Preferred Project Report

78-90 Old Canterbury Road, Lewisham

MP08_0195MOD1

23 April 2013

Proposed Concept plan Green space Area Diagram

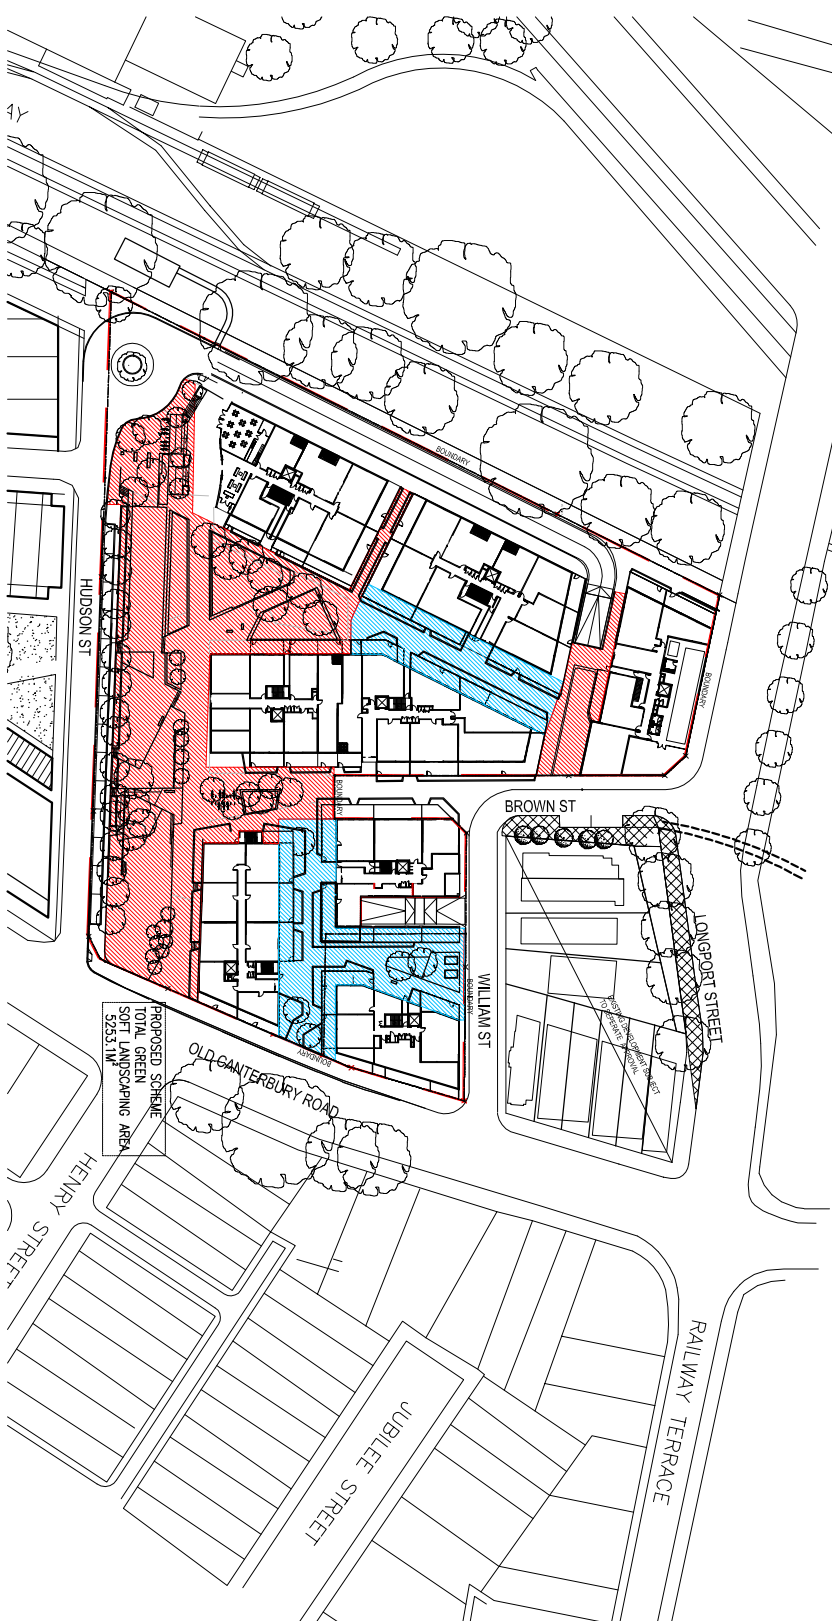
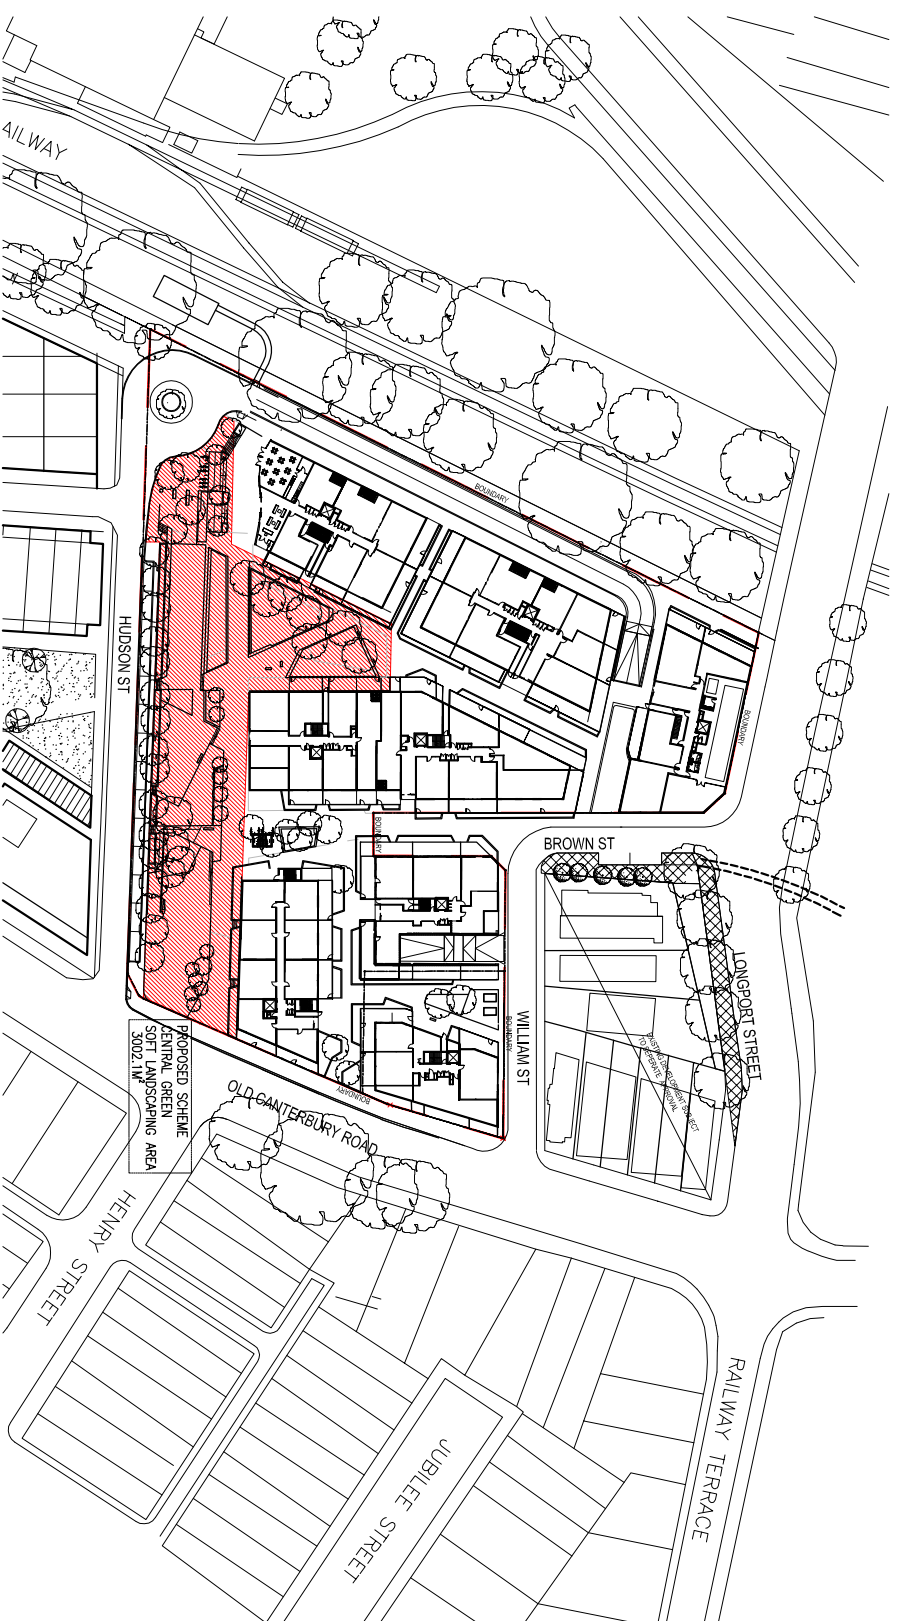
While not discussed in the proponent's s.75W report, one of the most significant modifications proposed is the alteration of *Drawing 22.1 Green Space Calculation Analysis (800 Revision E)*, which is linked to Condition A2 of the Concept Approval. This amended drawing will result in significantly reduced public access through the development as a result of the conversion of previously public open space to private open space.

Of particular importance are the north-south pedestrian connections between the light rail stop and William Street. Council notes in the amended drawing that a narrow 1m wide north-south public access path will be provided through the site from Brown to Hudson Street. This width is inadequate. All these pedestrian connections, previously advocated by Council, not only facilitate pedestrian permeability through the site but also assist pedestrian movements away from Old Canterbury Road at Hudson Street where no signalised crossing will exist.

The public open space between Buildings C and F has been reinstated as originally approved in the concept plan to ensure the integrity and amenity of the public pedestrian and cyclist access through the site. Refer Drawing 22.1 at **Annexure 3**.

The public open space areas, including between Buildings C and F, have been reinstated as originally approved in the concept plan to ensure the integrity and amenity of the public pedestrian and cyclist access through the site. Refer Drawing 22.1 at **Annexure 3**. The plans also confirm that the Hudson Street public park will achieve the 3,000 sqm metre area required by condition B3 of the consent.

12.5 SUBJECT SITE MASTER PLAN (REV D)
22 MARCH 2013

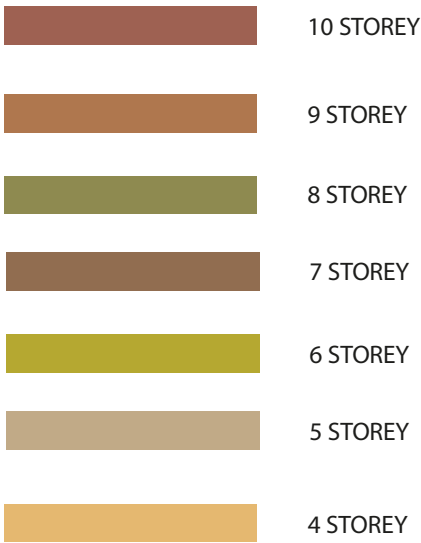
It is also noted that the drawing 12.5 Building Height shows the south end of buildings E and C penetrating into the pathway on the northern end of the main open space, which appears to reduce the required 20m minimum width of the open space (excluding on-street parking and adjacent footpath) under condition B3 of Part B: *Modifications of the Concept Approval*. This is unacceptable and should be rejected to maintain a clear width of path and view, with Building A being as a minimum behind that view line, but preferably set back as per the original approved plans.

12.3_SUBJECT SITE MASTER PLAN (REV D)
22 MARCH 2013

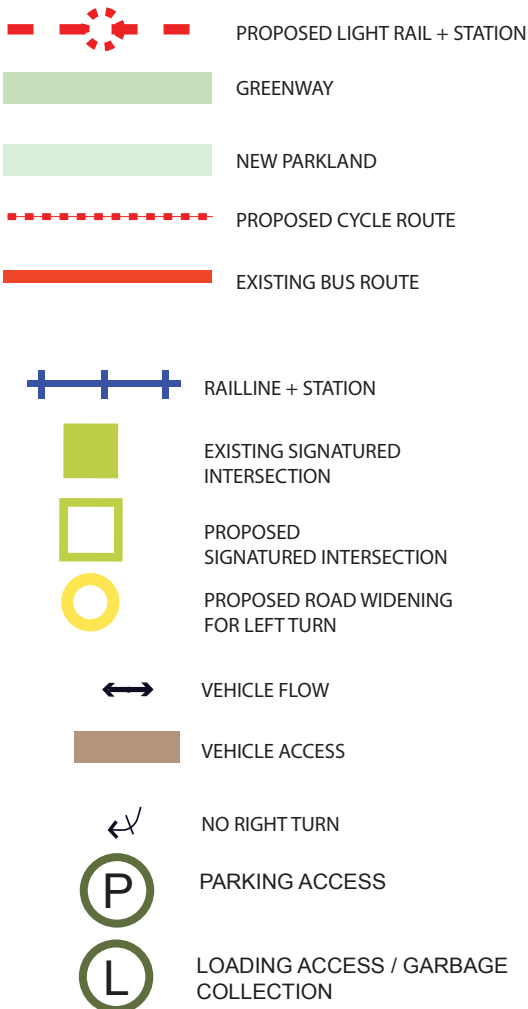
Council notes that Figure 12.3 of the proponent's modification report includes a proposed signalised intersection at Old Canterbury Road and Hudson/Henry Streets, but these signals have been rejected on multiple occasions as a possibility by Roads & Maritime Services (RMS). Furthermore, s.75W report Figure 12.2 includes a statement that the boulevard along Hudson Street *"creates a linkage from Henry Street to the greenway and provides single intersection access..."*, which in fact will not be the case. This means pedestrians and cyclists will need to use the existing crossing at Old Canterbury Road/Longport Street and will access this crossing using the north-south links.

There is a lack of clarity about how pedestrians are most likely to cross Old Canterbury Rd or Longport St. to access Lewisham Station. This is a vital consideration and needs to be clarified by the proponent. For example, Fig 12.3 of the proponent's modification report proposes a signalized intersection at Old Canterbury Rd and Hudson/Henry St., which has been rejected by the Roads and Maritime Services on several occasions. Similarly, Annexure 2 (under access) identifies a proposed public footbridge from the North end of Brown St., which presumably will go across Longport St. to the railway embankment? The drawings do not detail this overhead bridge. These very important pedestrian linkages need to be properly articulated by the developer and consistent with the traffic authorities' requirements.

- PAC initially imposed condition B2 on the consent, which requires the deleted loading facilities originally shown on the concept plan. Since the consent was issued, extensive consideration has been given to the possible location of these facilities on the site given the various constraints. It has been determined that the best possible location is beneath the eastern end Building D, as indicated on amended drawing No. 12.3 (refer **Annexure 3**).

The vehicular access point in William Street is proposed to be reinstated. The access point will be located beneath Building F, as originally approved in the concept plan. Refer to amended Drawing No.12.3 at **Annexure 1**.

The vehicular access point in William Street will be reinstated. The access point will be located beneath Building F, as originally approved in the concept plan. Refer to amended Drawing No.12.3 at **Annexure 1**. Accordingly, no amended/additional traffic reporting (as requested by the Department) is necessary.
